## **STONE HEDGE SUBDIVISION, UNIT FIVE**

***Revised for the September 21<sup>st</sup> meeting:***

# DETAIL SITE PLAN

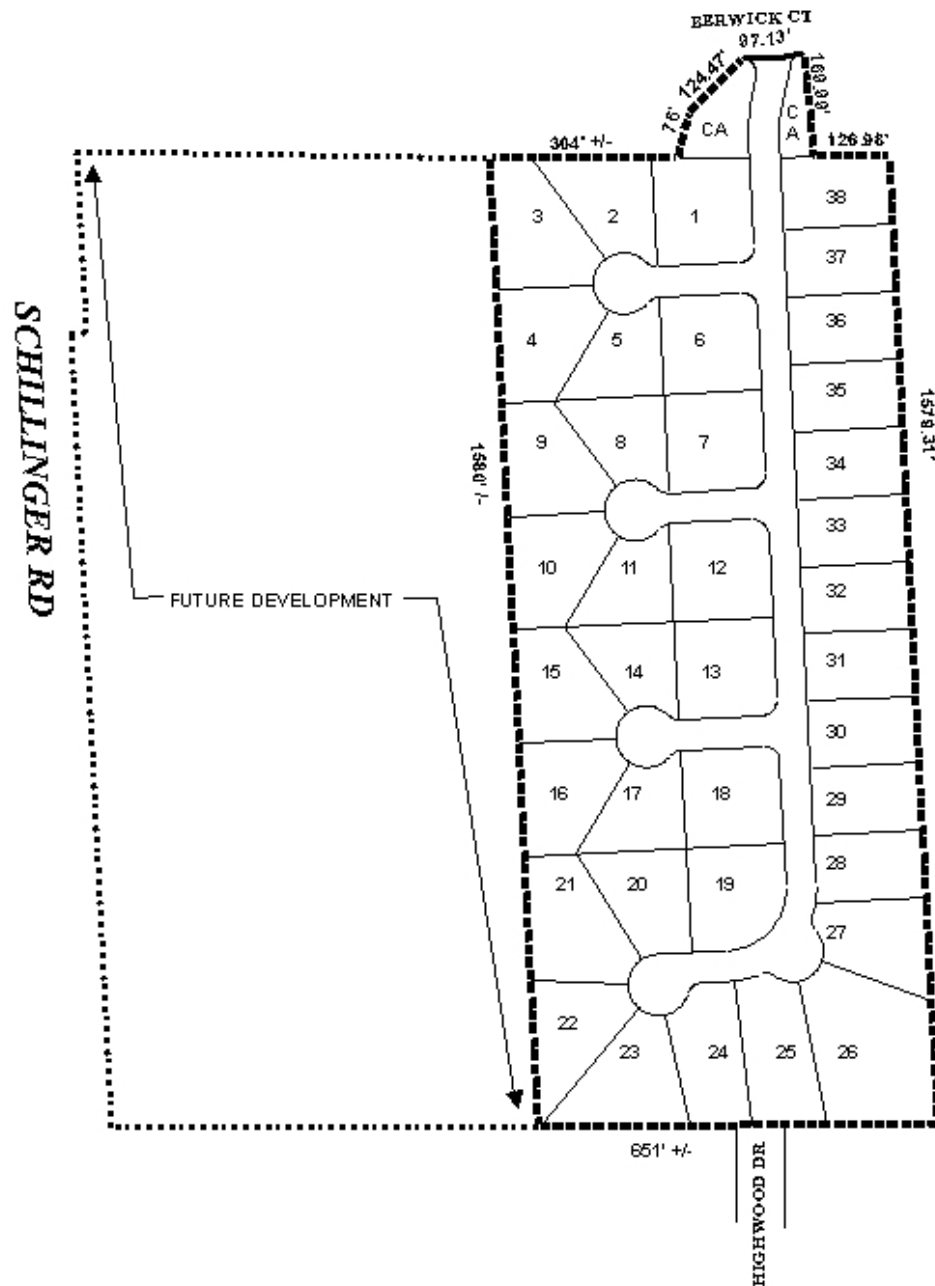
The proposed 38 lot development will not front onto a major street, but will instead connect to Berwick Court via an existing lot. As previously mentioned, Highwood Drive stubs into the South side of the proposed subdivision, however the applicant is not proposing to connect to Highwood Drive. The Subdivision Regulations recommend connection to adjacent street-stubs, and the provision of street-stubs to large undeveloped tracts of lands. The site in question has both conditions, thus the plat should be revised to provide a connection to Highwood Drive and provide one street-stub into the area reserved for future development.

All proposed lots appear to meet the minimum size requirements of Section V.D.2. of the Subdivision Regulations. To ensure lot size conformance, it is recommended that the plat be revised to include the size of each lot in square feet as a label on each lot, or as a table on the plat.

The 25-foot minimum building setback line, required in Section V.D.9., is not shown for the subdivision, but would be required on the final plat, if approved.

As previously mentioned, lot 37 of Unit One will be cannibalized to create access for the proposed subdivision to Berwick Court. The portion of the lot that is not used for the road will become common area. A note should be placed on the final plat, if approved, stating that maintenance of common areas is the responsibility of the subdivision's property owners.

Finally, the legal description does not appear to include the future development area. The legal description should be revised to include the entirety of the lots and parcels in question.

*No stormwater detention facilities are depicted on the plat, however, such facilities may be required.*

*Based on the preceding, the subdivision is recommended for Tentative Approval, subject to the following conditions: 1) placement of a note on the plat stating that dedication of right-of-way sufficient to provide 50 feet, as measured from the centerline of Schillinger Road, will be required when the "future development" area is subdivided or developed; 2) redesign of the subdivision to provide a street connection to the Highwood Drive stub; 3) provision of a street-stub to the future development area; 4) labeling of all lots with size in square feet, or placement of a table on the plat containing the lot size information; 5) labeling of all common areas and detention areas if provided, and placement of a note on the final plat stating that maintenance of the common and detention areas is the responsibility of the subdivision's property owners; 6) depiction of the 25-foot minimum building setback line; 7) placement of a note on the Final Plat stating that any lots which are developed commercially and adjoin residentially developed property must provide a buffer, in compliance with Section V.A.7. of the Subdivision Regulations; and 8) revision of the legal description to include the entirety of the development site, including the future development area.*
